Voluntary Emission Reductions in Rice Management Systems v1.0 and Regional Calibration Modules Errata & Clarification November 2016

This is a supplemental document to the ACR Methodology *Voluntary Emission Reductions in Rice Management Systems*, v1.0 and its Regional Calibration Modules. The ACR Methodology *Voluntary Emission Reductions in Rice Management Systems* v1.0, and all subsequent versions of this methodology, is considered the “Parent Methodology” for both the Midsouth and California modules.

Figure 1. Flow chart of Crediting Period, Project Renewal and Baseline Update.

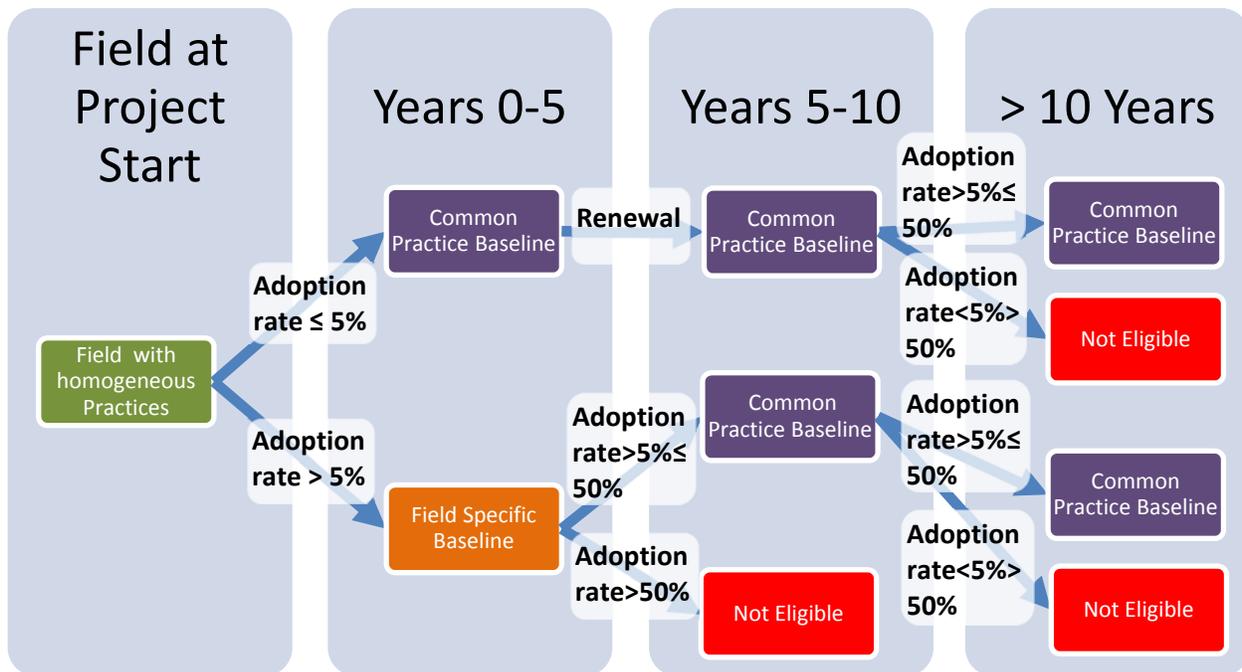
In the parent methodology, “Baseline adoption rate” refers to the baseline adoption rate of the project activities. When a Project Activity is implemented on less than 50% of the acres in the Rice Growing Region, it is considered a practice that is not commonly used, and is therefore eligible for a Common Practice Baseline after year ten. The flow chart is provided to better explain the different baselines allowed. Adoption rates of a specific practice are assessed on an annual basis. At validation of an initial Crediting Period, one annual adoption rate in the past five years suffices to set the baseline adoption rate. However, upon renewal of a project’s Crediting Period the baseline adoption rate must be set as

the average of at least two adoption rates in the five years preceding the Crediting Period. Often little data is available for a given practice initially at project start, but the practice is adopted more readily over time.
